Re: Plumas District Hospital; Skilled Nursing Facility

Plumas District Hospital ("District") submits this letter and the enclosed documents in supplement of its April 15, 2021 Special Use Permit Application for the proposed Skilled Nursing Facility ("SNF") on Bucks Lake Road in Quincy (APN Nos. 115-210-009, -019, and -020). The District encloses with this letter the following documents, which includes a revised SNF site plan:

SUBJECT: Preliminary Drainage and Stormwater Quality Study for the Plumas District  
Hospital Skilled Nursing Facility  
(RICK Job Number: 19314)

**ATTACHMENT B**

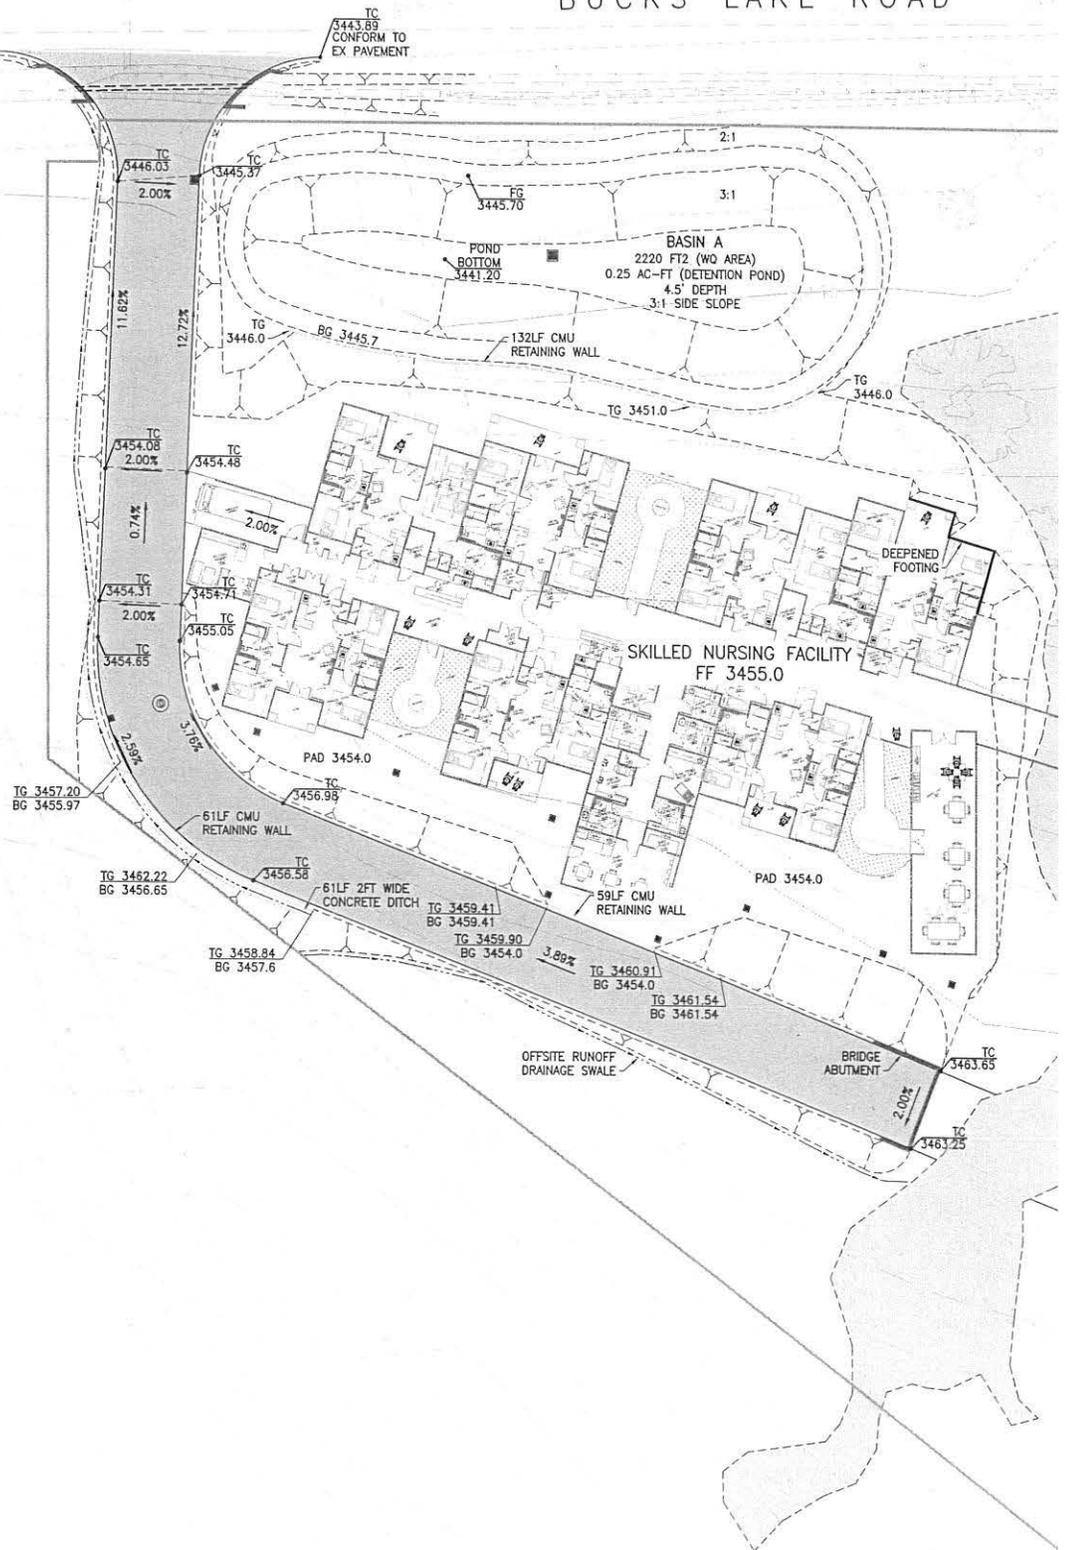
DPW requested that the District provide a drainage analysis and appropriate mitigation, prepared by a registered civil engineer.

This letter also includes a Preliminary Grading Plan (Attachment "B"), also requested by DPW. The Preliminary Grading Plan and revised Site Plan (Attachment "A") each reflect the proposed infrastructure that the Drainage and Stormwater Quality Study assessed. This infrastructure is designed to capture run-off and mitigate the risk of any increased drainage onto adjoining properties that could result from construction of the SNF.

Enclosed as Attachment "D" please find a July 2, 2021 Preliminary Drainage and Stormwater Quality Study for the Plumas District Hospital Skilled Nursing Facility. The enclosed study summarizes the District's hydrologic analyses and criteria for designing on-site mitigation, like the detention basin, retention basins, and storm drain system.
